Our ref: 486-01/IJM-PD

17th December 2019

Application Reference P/19/0525 – Erection of Aldi Foodstore - Gresford Road, Llay

I refer to your comments pertaining to matters presented in the application reference P/19/0525 dated 24th October.

Figure 1 – Active Travel Routes to the Site

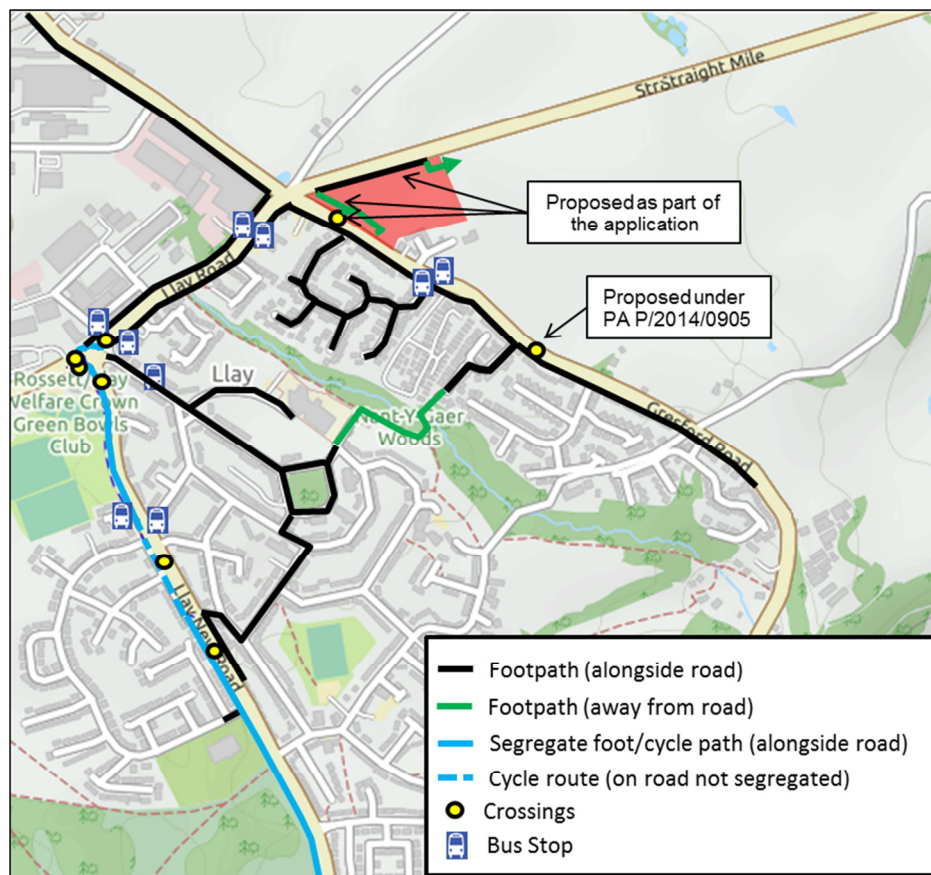
As can be seen from Figure 1, the site benefit from a well-connected network of walking routes provided by a number of footpaths across the local area, and good connectivity by footways provided adjacent to the highway. This provides direct access to a wider number of residential properties in the local area and makes walking or cycling to the development readily available. A suitable level of street lighting is present throughout the area.

486-01/GA-06

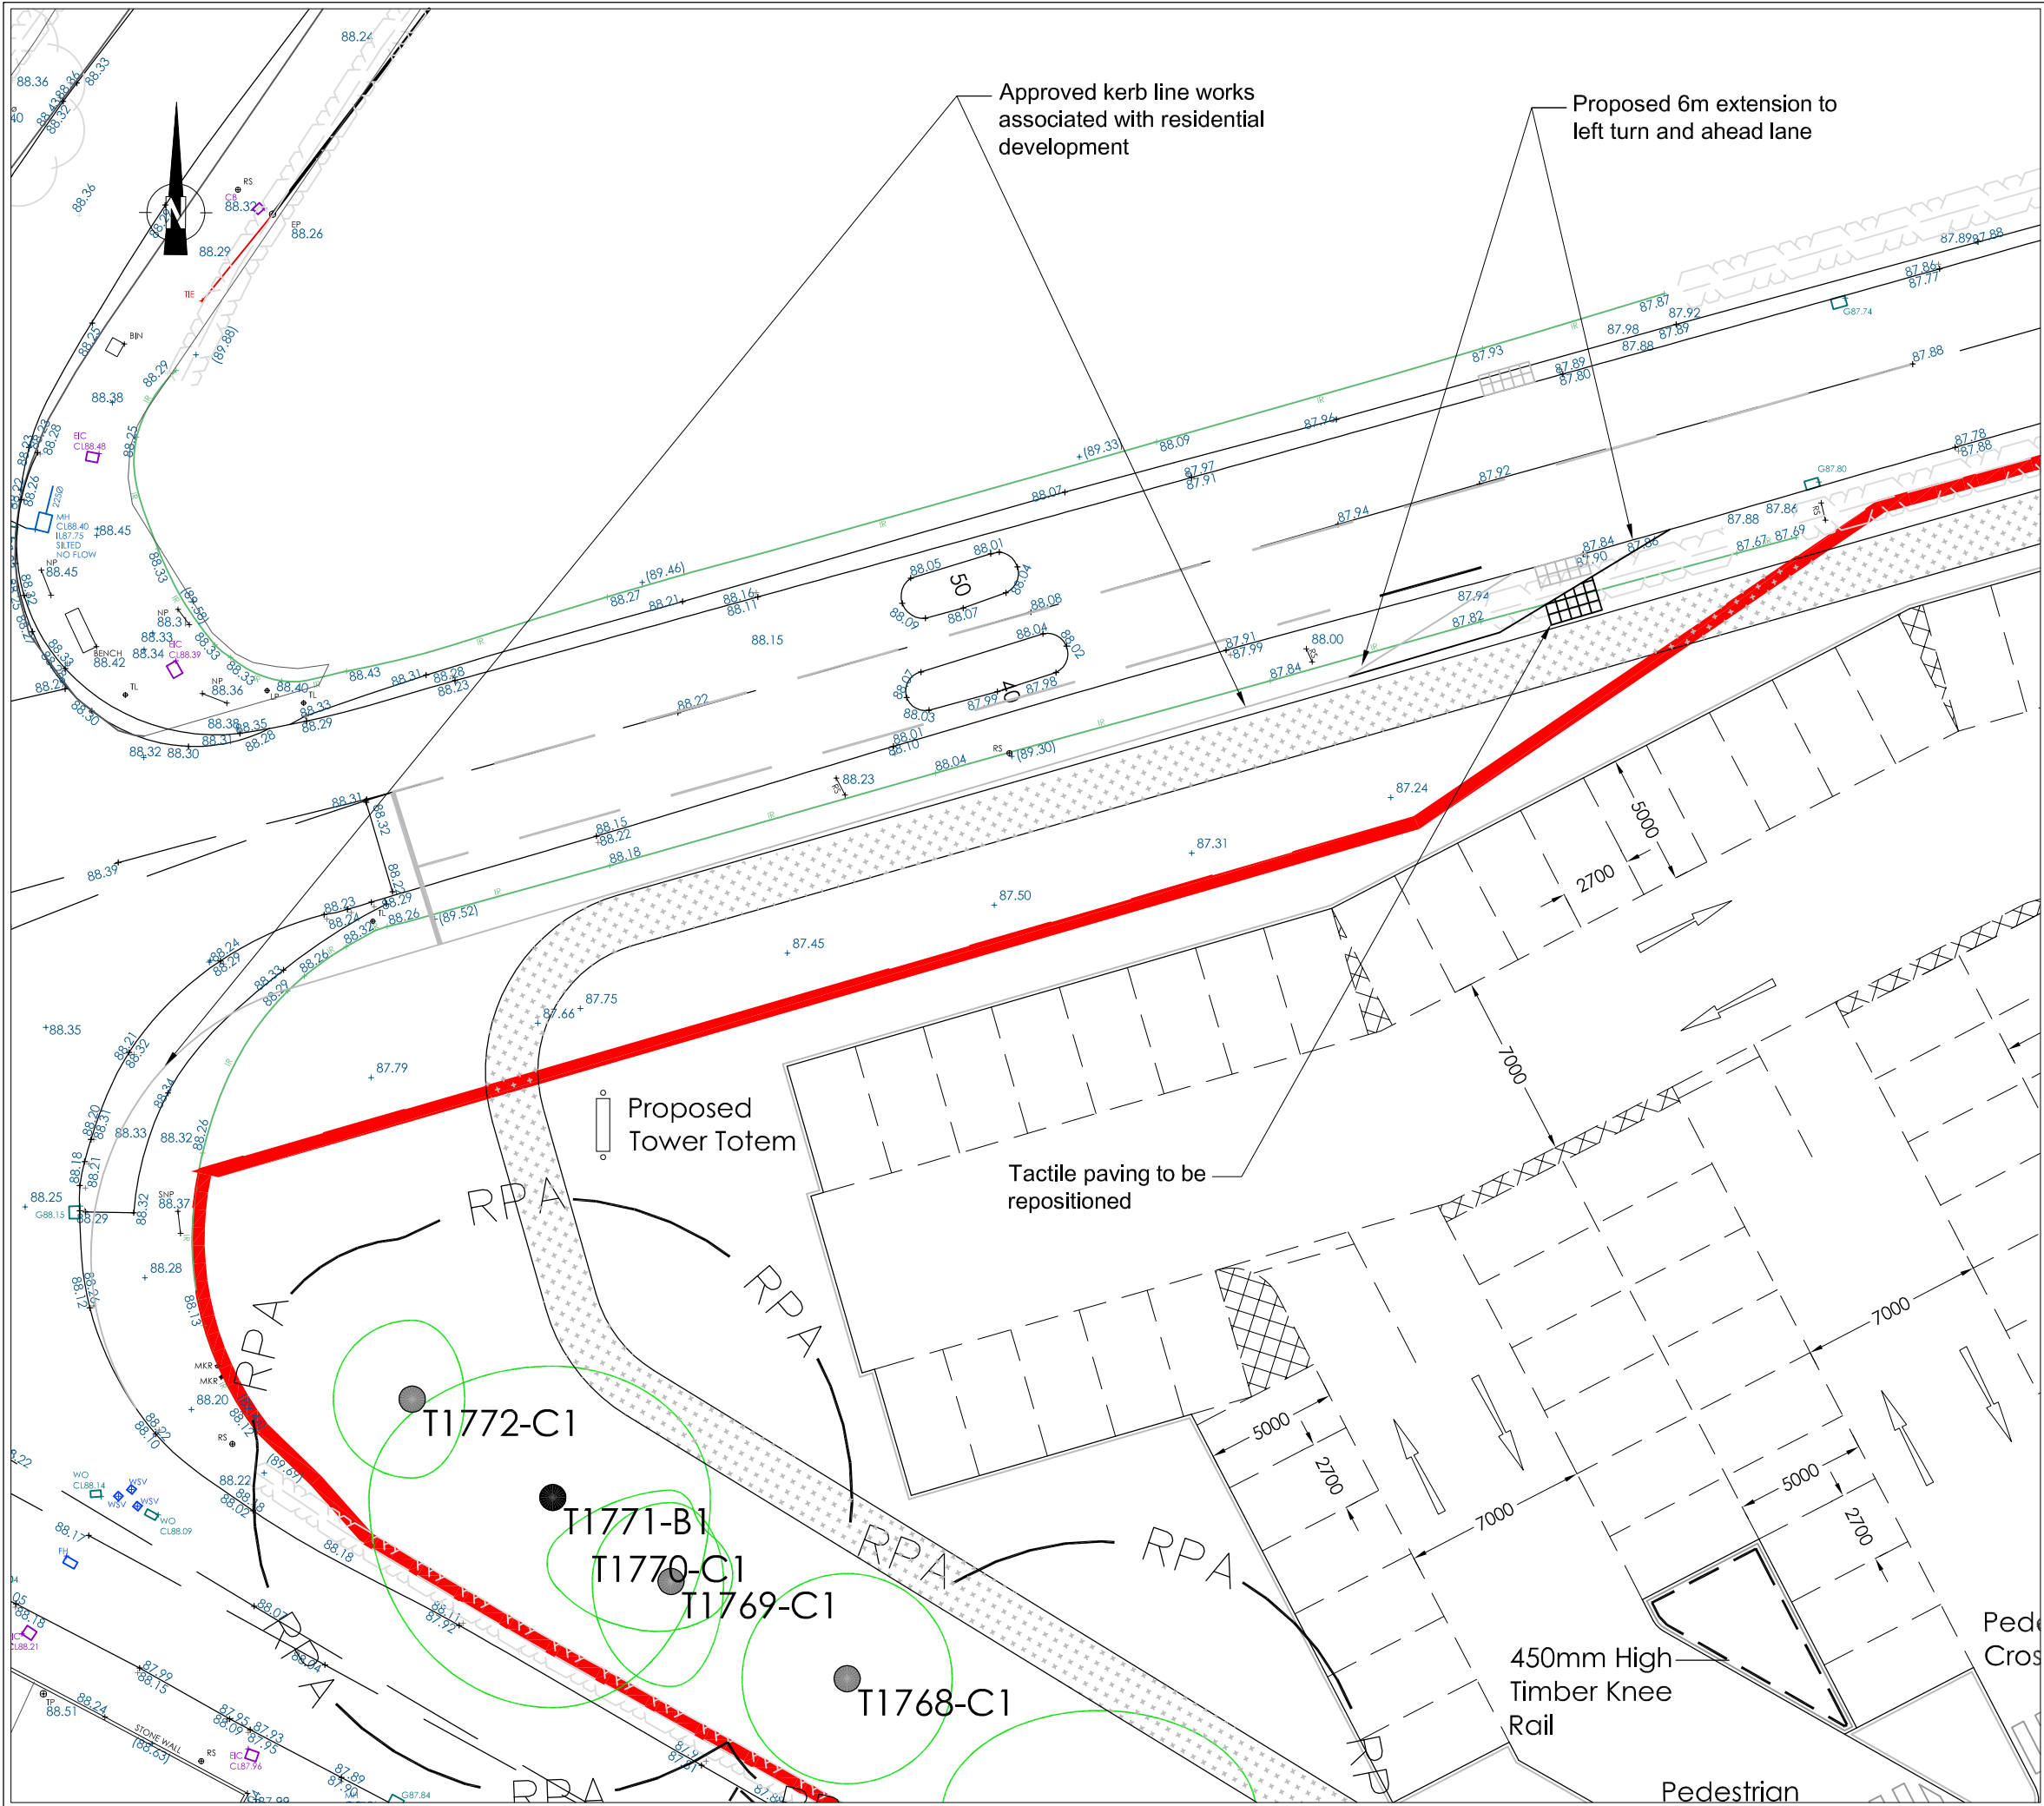
Left Turn Only from Straight Mile

As with the zebra crossing design we would be happy to progress this left in only access design to detailed design level and stage 2 road safety audit upon reaching an agreement in principle on all other matters presented above.

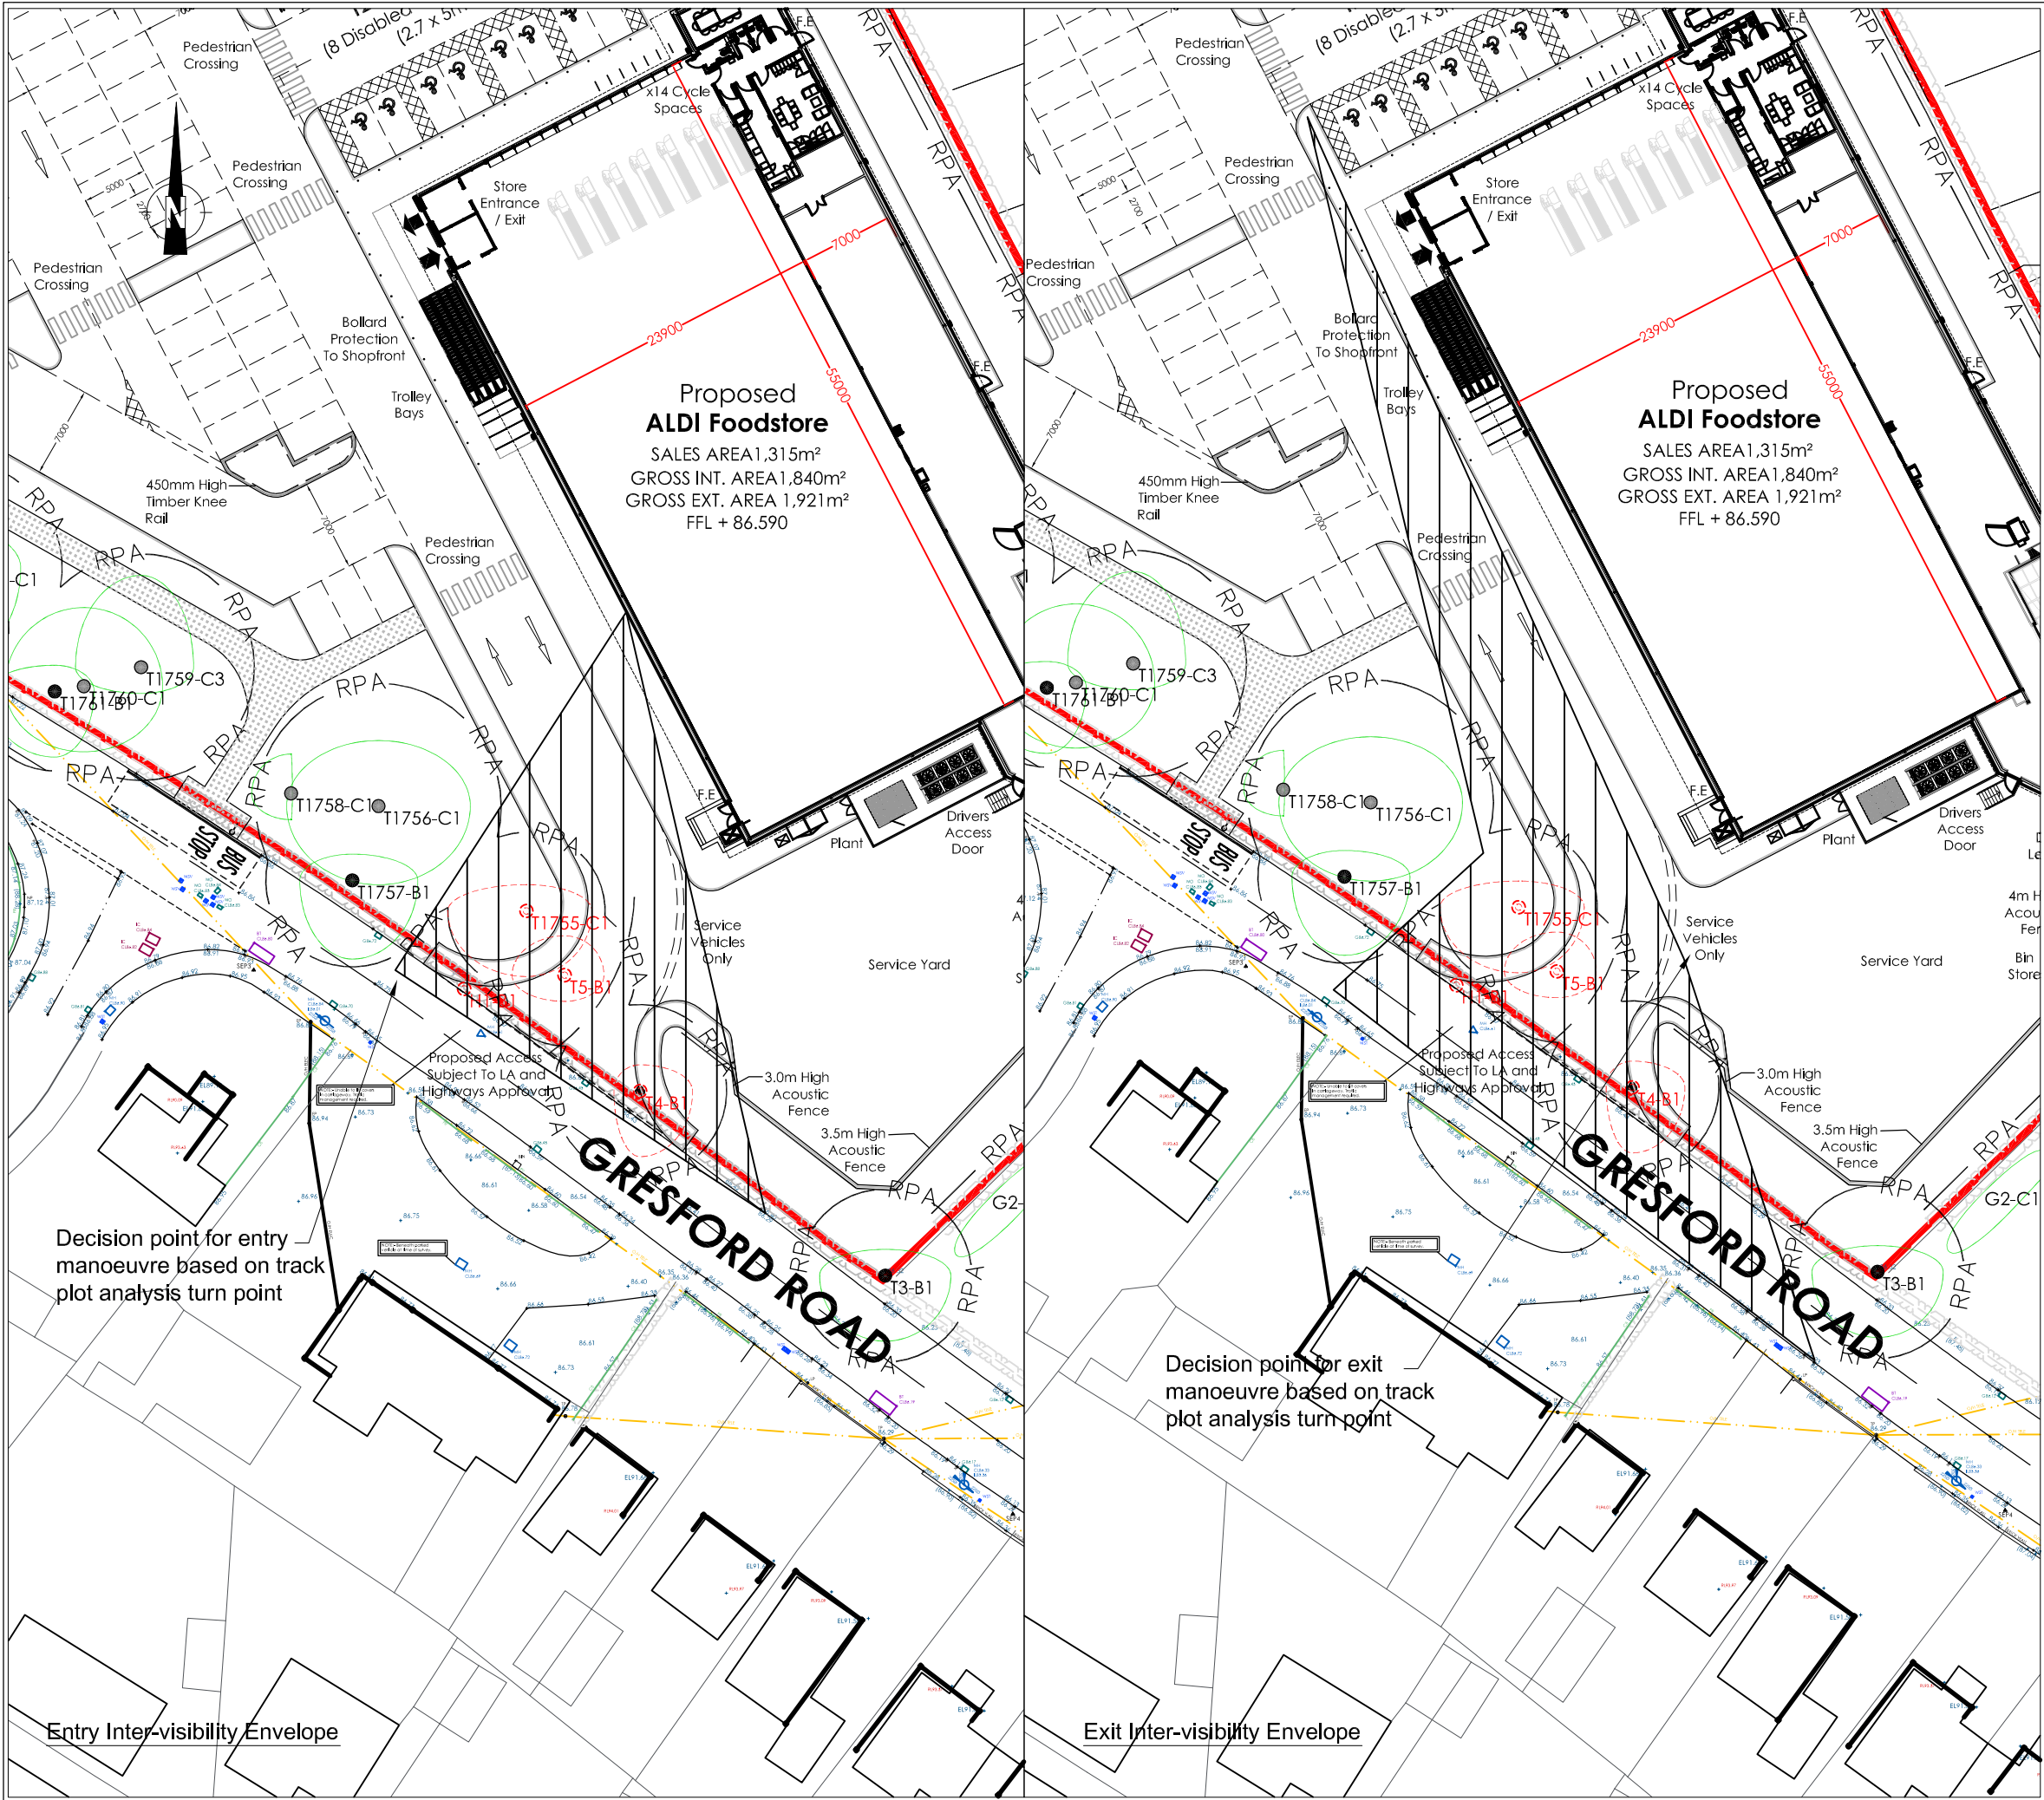
HGV Swept Path Analysis

The drawings submitted clearly illustrate the inter-visibility availability at the junction; notwithstanding this drawing 486-01/GA-07 presents a visibility envelope for approaching and departing HGV's
